Access Compliance Report Public Rights-of-Way (Curb Ramps)

Main Street: O_NEILL_DR Cross Street: NARROW_CANYON_RD Location: S

ADA ID: RPRK211027123651 Ramp Type: Type 6 - Directional 1 Initial Pass/Fail: Fail Overall Compliance: No Severity Score: 15

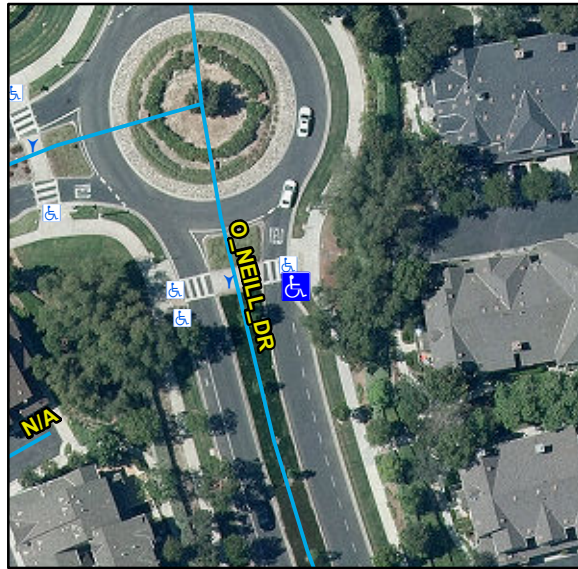
Compliance	Description	Data	Compliance	Description	Data
N/A	Ramp Length (in)	135	N/A	Flare Type LT	
Yes	Ramp Width (in)	48			N/A
No	Ramp Run Slope (%)	9.9	N/A	Flare Slope LT (%)	N/A
Yes	Ramp Cross Slope (%)	0.4	N/A	Flare Traversable LT	N/A
N/A	Grade Break	N/A	N/A	Flare Type RT	
N/A	Grade Break Slope (%)	N/A			N/A
N/A	Grade Break Cross Slope (%)	N/A	N/A	Flare Slope RT (%)	N/A
	Addl Para Ramp Left?	No	N/A	Flare Traversable RT	N/A
	Addl Para Ramp Right?	No	N/A	DWS Provided	N/A
N/A	Landing Present	N/A	N/A	DWS Contrast	N/A
N/A	Landing Length (in)	N/A	N/A	DWS Length (in)	N/A
N/A	Landing Width (in)	N/A	N/A	DWS Full Width	N/A
N/A	Landing Run Slope (%)	N/A		DWS Offset Type	N/A
N/A	Landing Cross Slope (%)	N/A	N/A	DWS Left Offset (in)	N/A
N/A	Landing Movement Obstructed?	N/A	N/A	DWS Right Offset (in)	N/A
	Landing Movement Type	N/A			
N/A	Landing Shared	N/A			
N/A	Marked Crosswalk 1	No	N/A	Clear Space	N/A
	Crossing 1 Direction	SW	N/A	Clear Space To Crosswalk (in)	N/A

Remove & Replace Entire Ramp.
